Apex House- Plymouth Grove

Pre- Commencement Planning conditions

Condition 9

REF: 13294/FO/2023

Appendix A: Proposed Drainage Layout

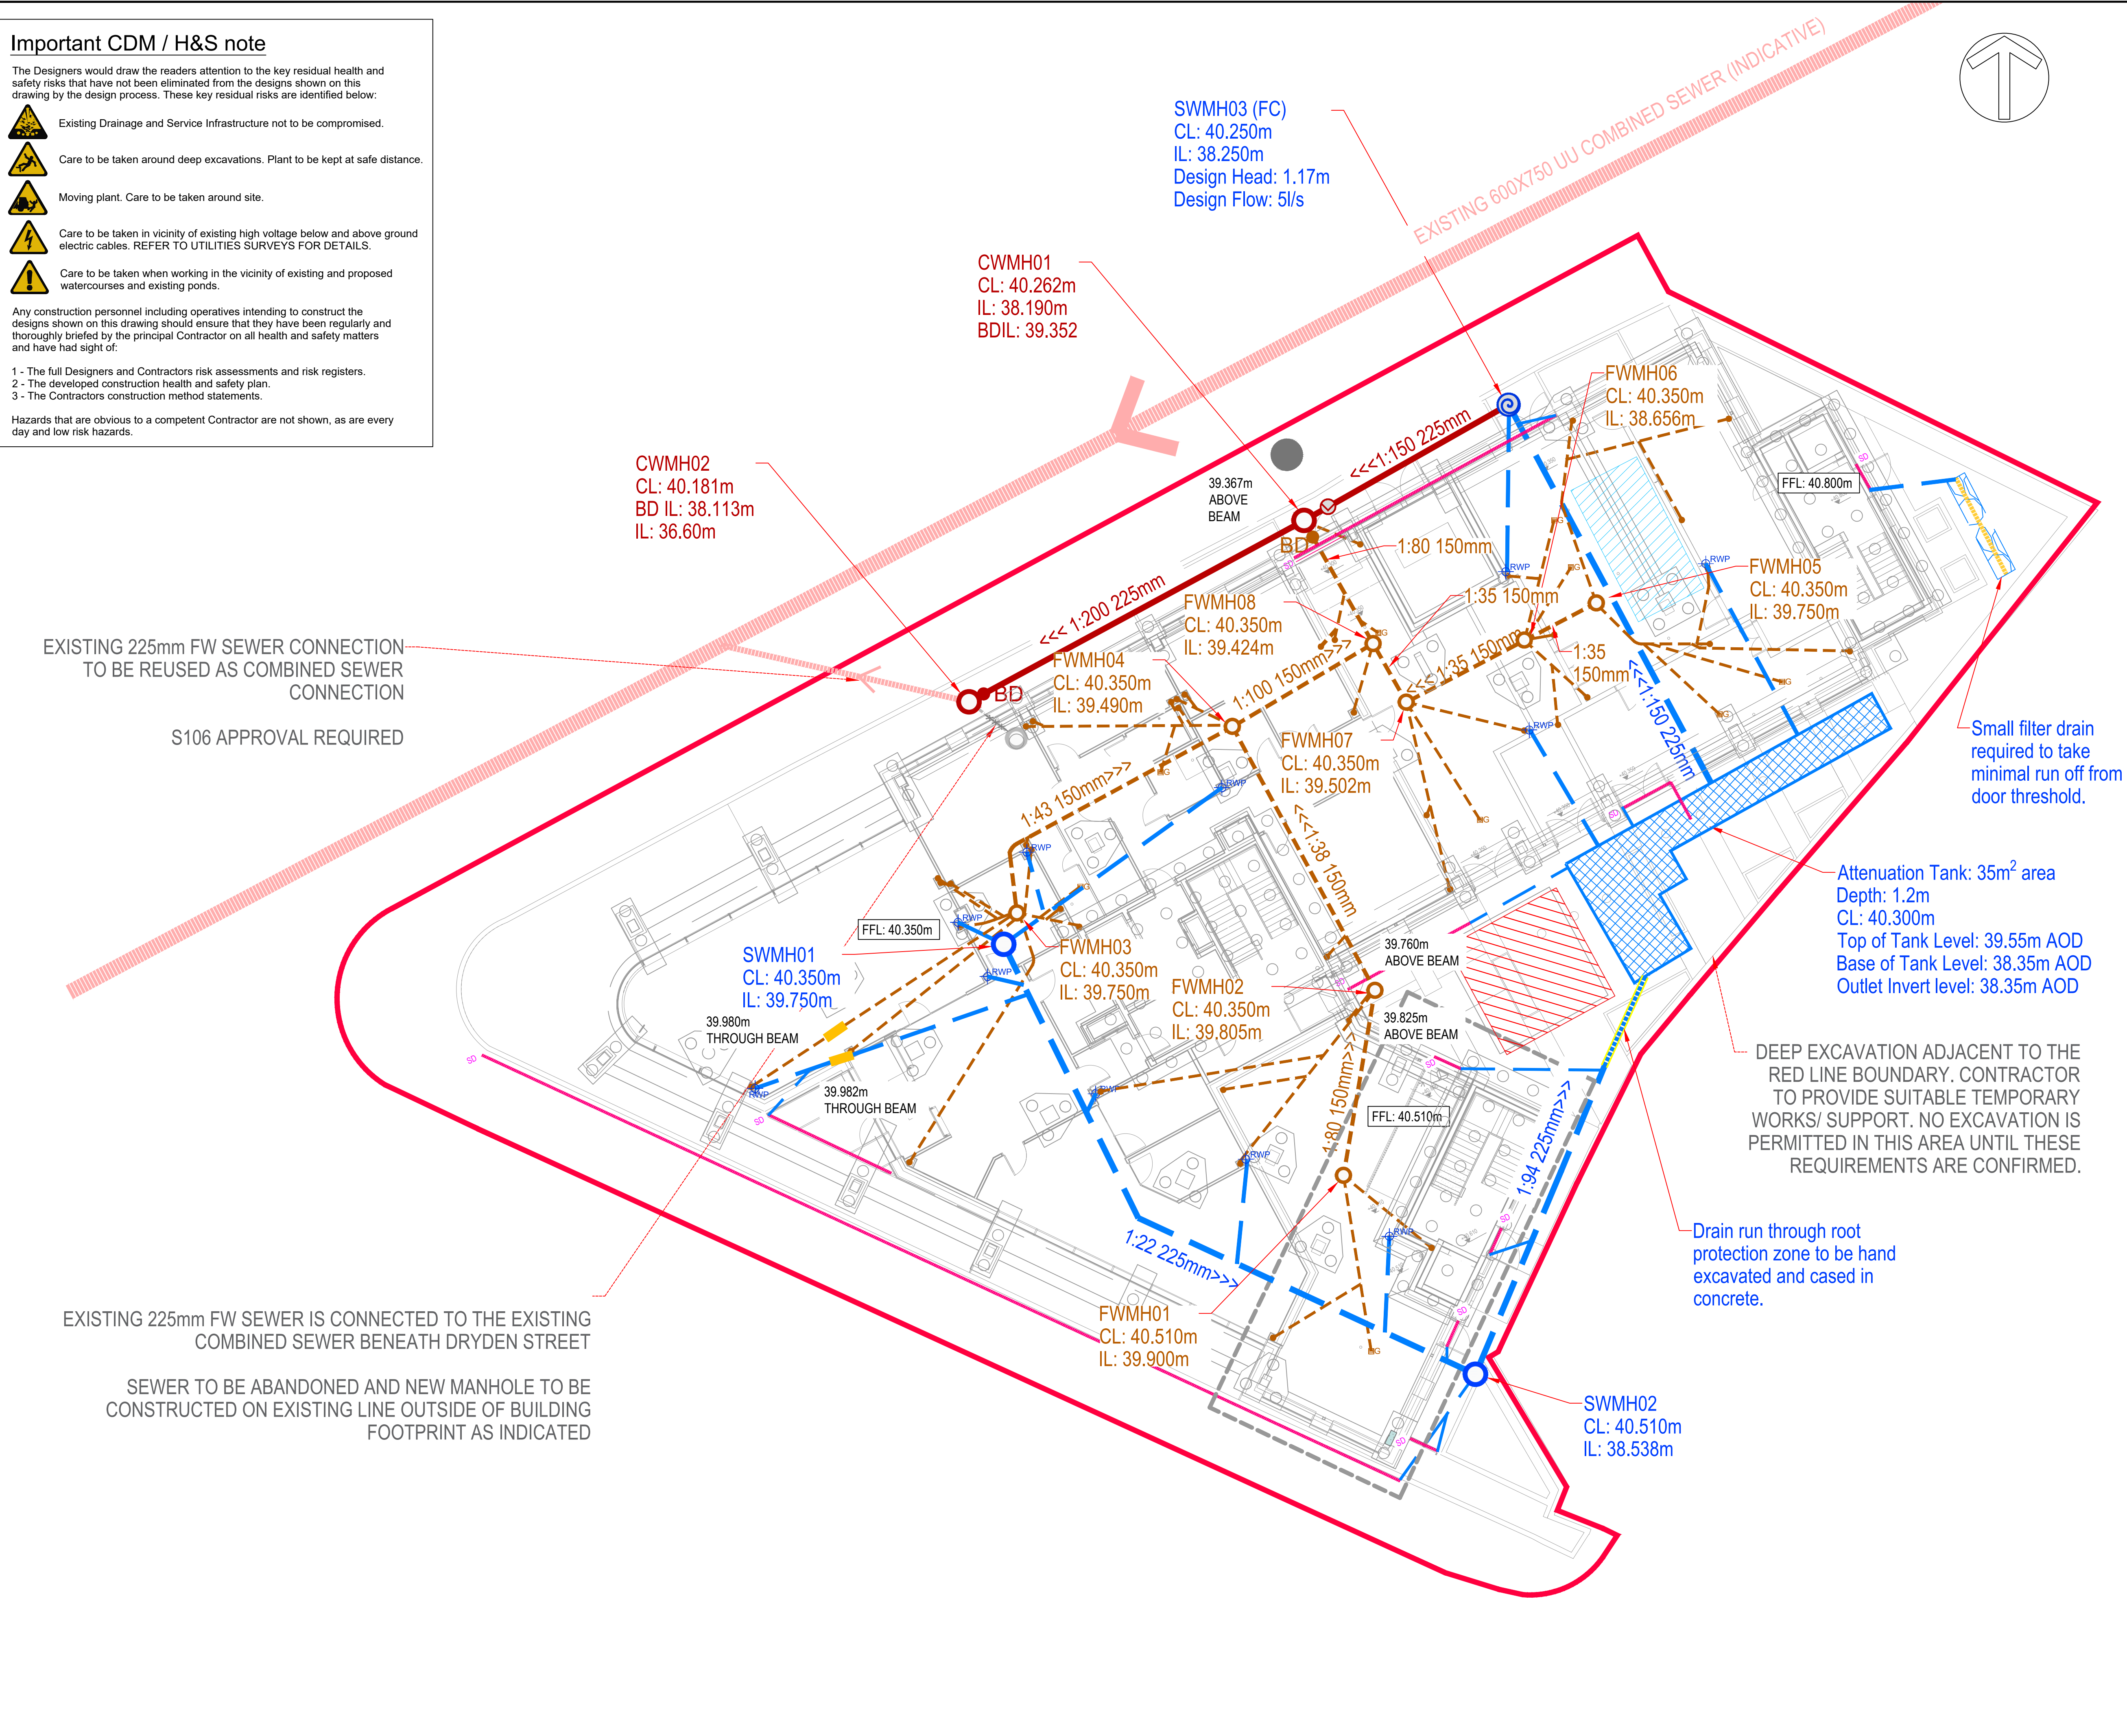
1. A finalised drainage layout showing all components, outfalls, levels and connectivity.

The finalised drainage layout has been attached in Appendix A- this revision includes all components, outfalls, levels and connectivity.
